AGENDA
DESIGN COMMISSION
Commissions Room - 2nd Floor
Arlington Heights Village Hall, 33 S. Arlington Heights Rd.
Arlington Heights, IL 60005
September 8, 2026
6:30 PM

REPORT OF PROCEEDINGS OF A MEETING
BEFORE THE VILLAGE OF ARLINGTON HEIGHTS
DESIGN COMMISSION

RE: 515 SOUTH CHESTNUT AVENUE – SF/TEARDOWN - DC #26-051

PROPOSED FRONT (WEST) ELEVATION

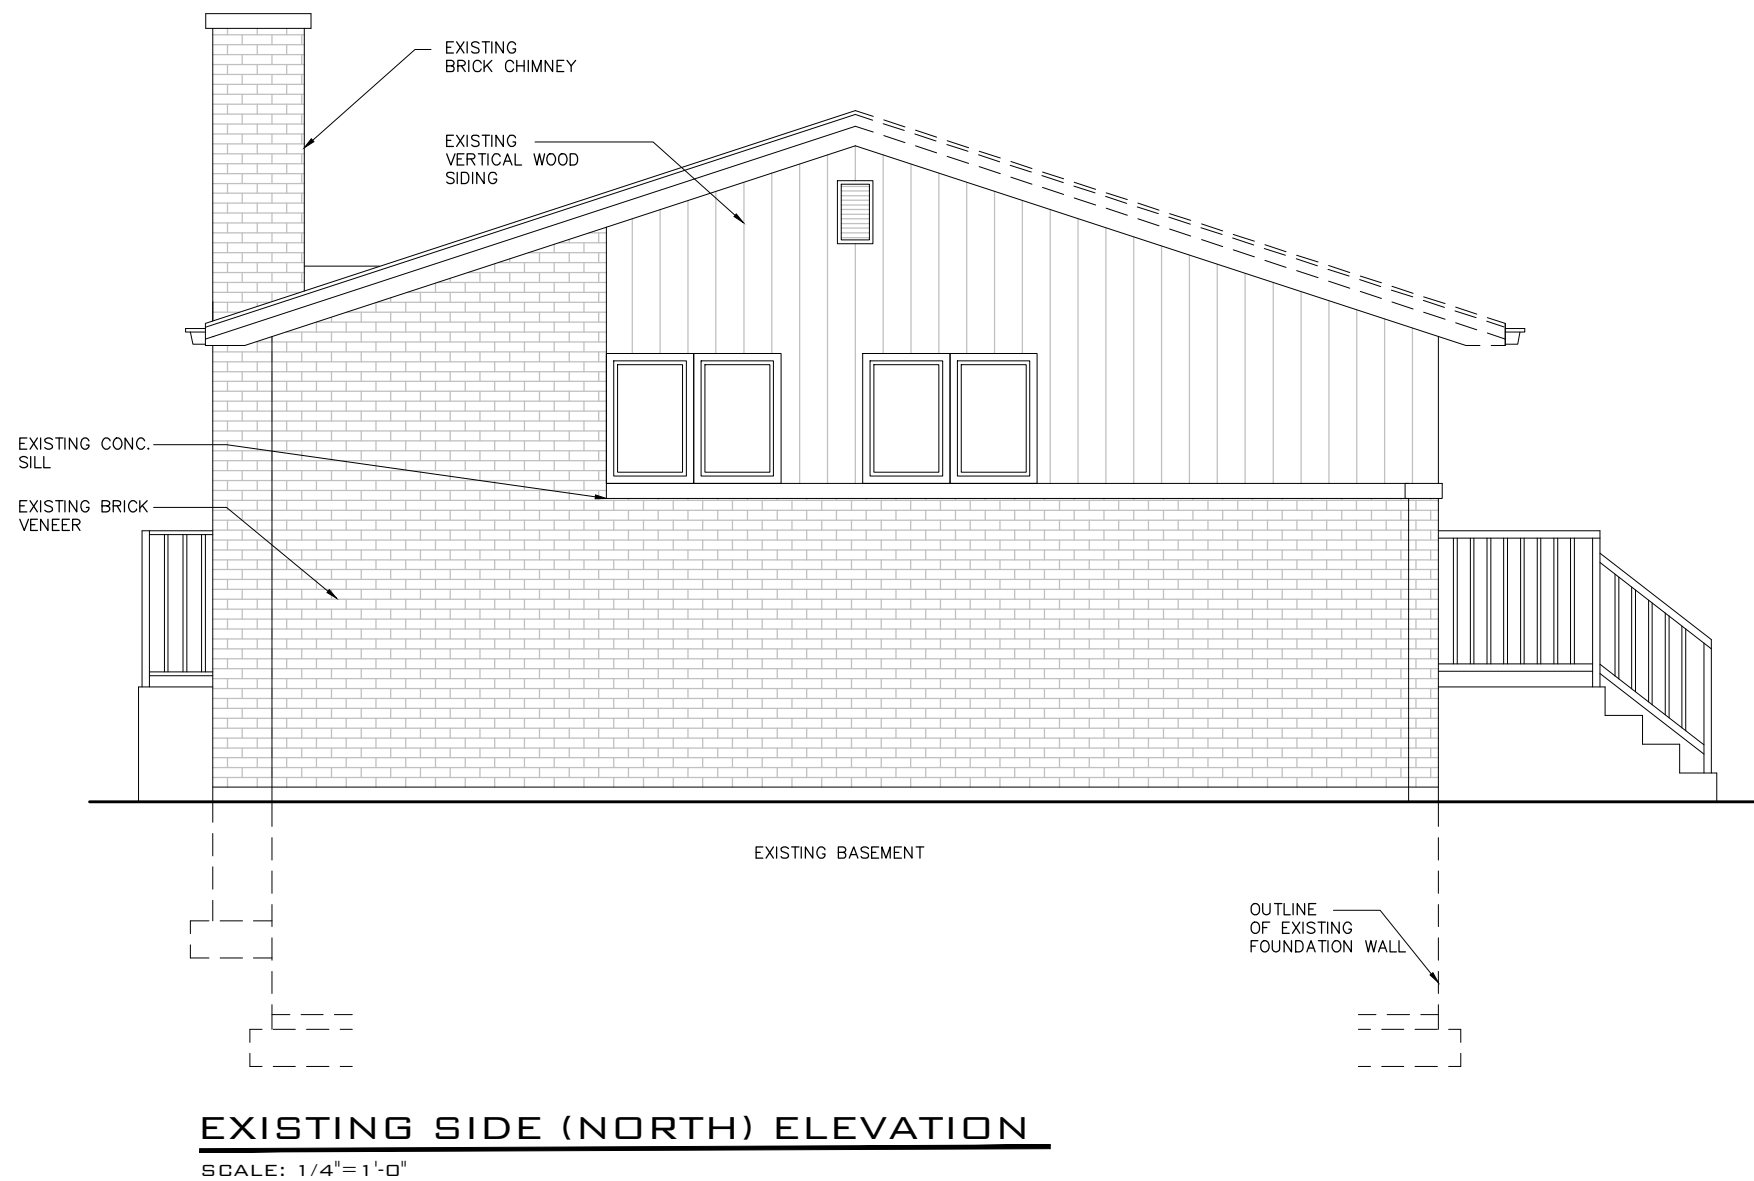
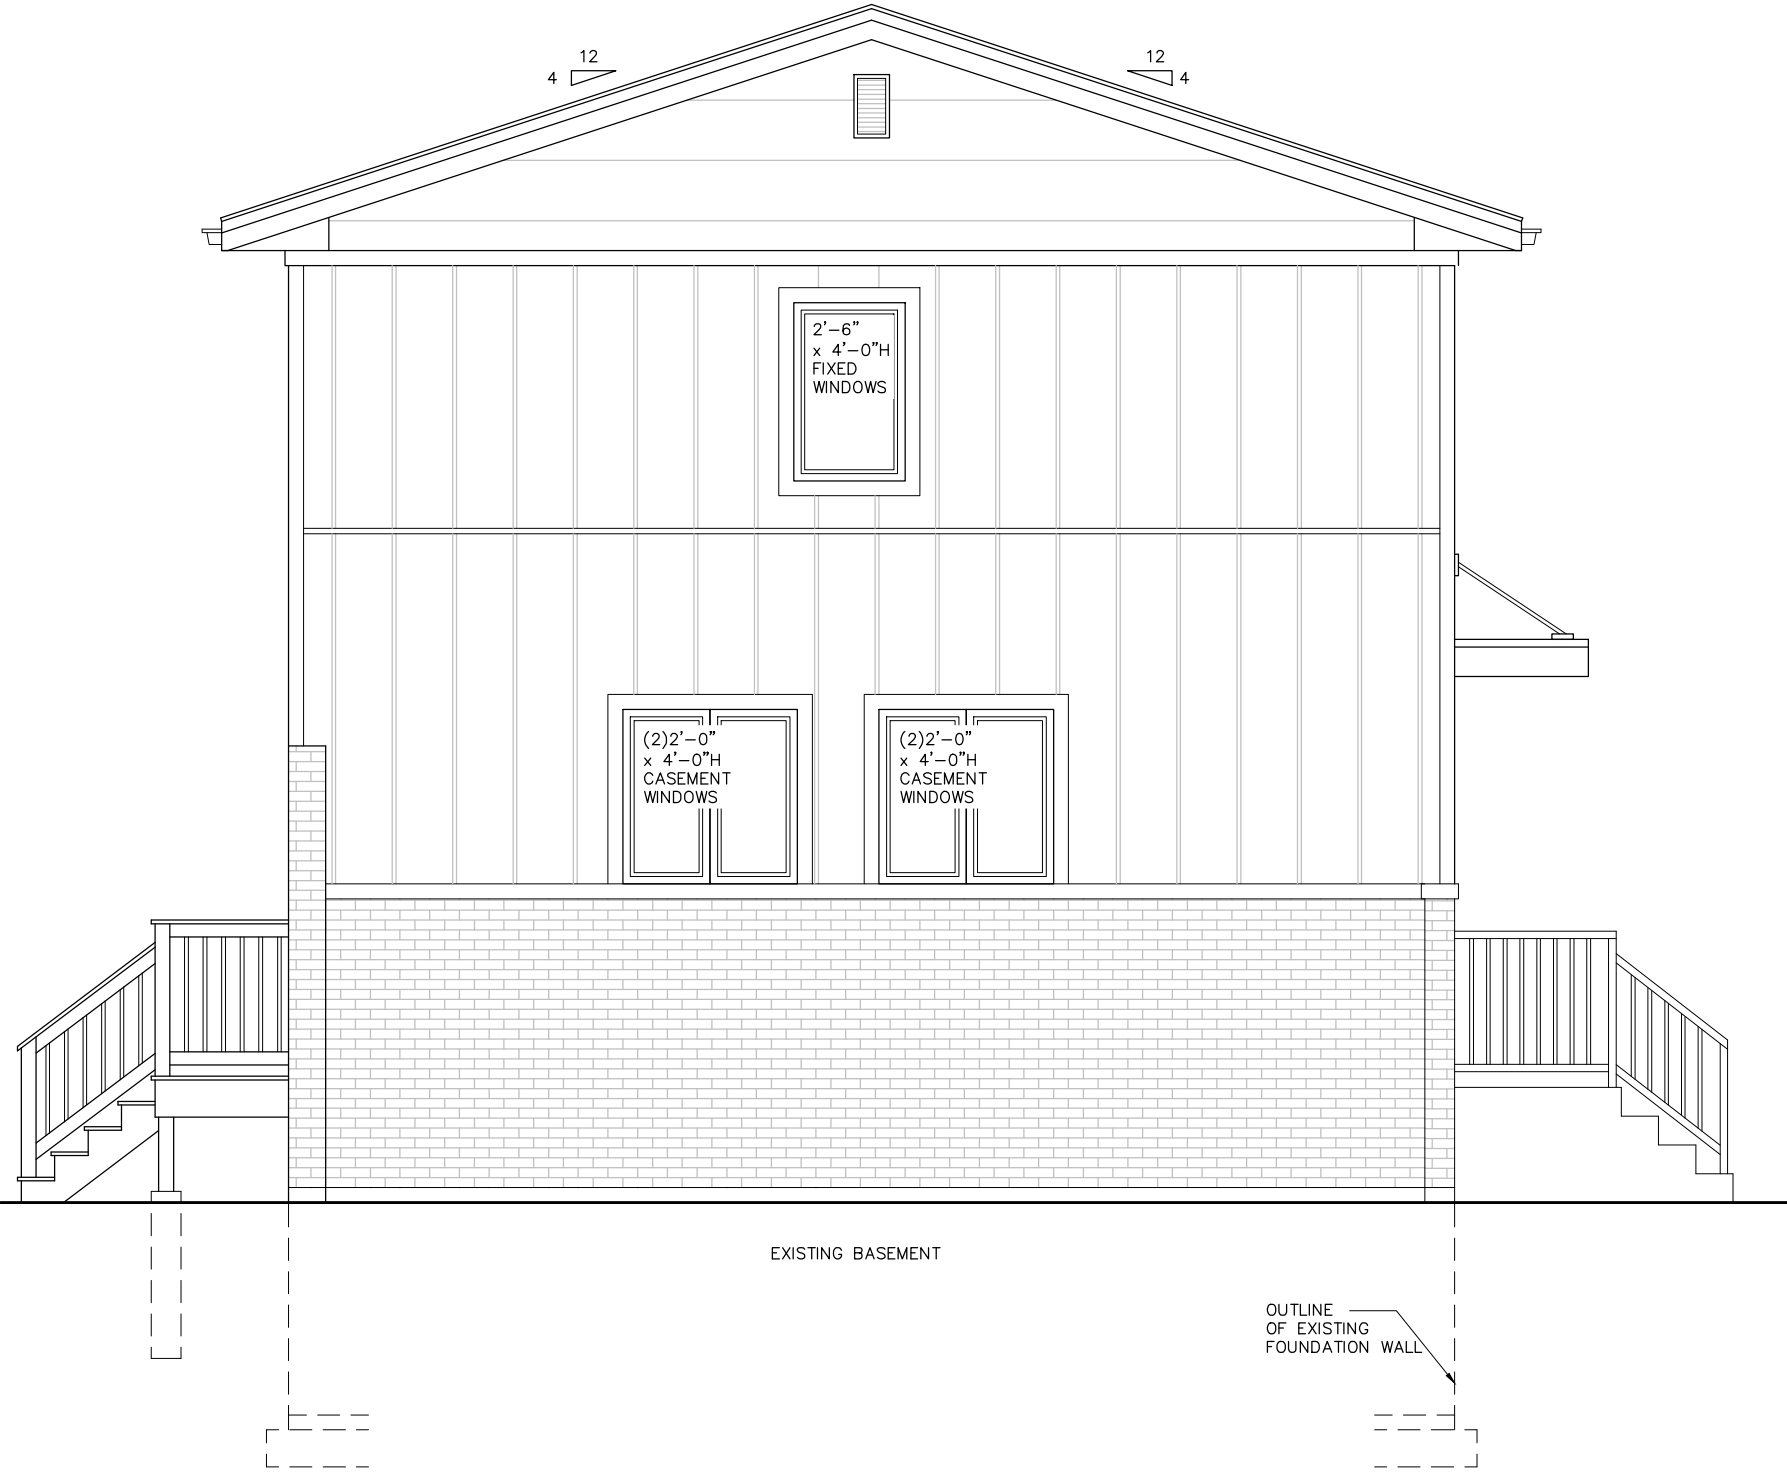
The proposed front porch is an unusual design with a steep two-story height that extends up onto the main roof of the house. A more traditional approach to a front porch addition would be a single-story roof that fits below the second story windows. While the proposed design is unique and interesting, it will be a significant change to the appearance of the existing house. The steep roof pitch is also mismatched with the lower pitch gable roof above the garage.
